AERONAUTICAL CHARTING MEETING
Instrument Procedures Group
Meeting 22-02 – October 24-25, 2022

RECOMMENDATION DOCUMENT

FAA Control # 22-02-373

Subject: Transponder slant codes on terminal publications

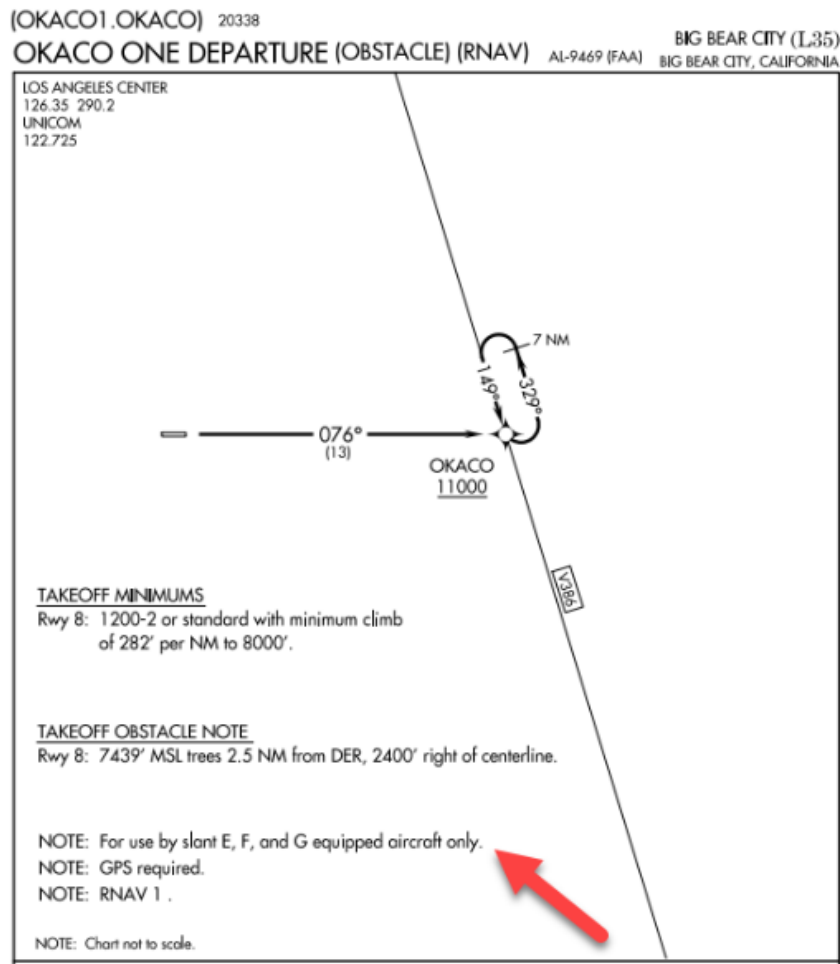
Some procedures, such as the Big Bear City (L35) Okaco One Departure reference “slant codes.” The codes refer to transponder equipment.

The problem appears to be with the advent of ICAO flight plan usage, there is no current FAA *pilot*-publication (the codes are referenced in FAA Order 7110.65(), but this is not a pilot publication) where pilots can get slant codes as they are not the same as ICAO surveillance codes.

If slant codes are still part of the NAS, update pilot-relevant publications (i.e., the AIM) with this information.
